Service Bulletin #120

Subject: Snow Blow-By At Deflector When In Side Discharge Position On 2HP Snowthrower

Models: 1850 - 55129 - 55130 - 55179 - 35250 - GIS7504A97 - 09GN5139 - 09GN5140

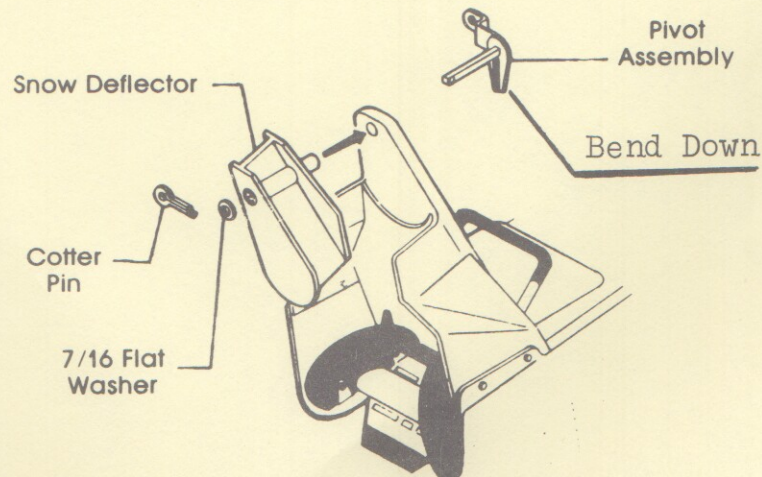
Reports have been received that a small amount of snow blows out between the auger housing and the side of the deflector in light loose snow.

Investigation showed that most of the snow is blowing out between the top of the deflector and the top leading extension of the deflector support.

To reduce blow-by, remove deflector pivot assembly, and bend the top rear detent section of pivot assembly down slightly. Remount pivot assembly and deflector. Clamp deflector tight to top extension housing using two "C" clamps or two vise grips, one on each side of center vane of deflector. Reinstall flat washers removed and add sufficient 7/16" thin washers to take out play between deflector and cotter pin. Install cotter pin, release "C" clamps or vise grips.
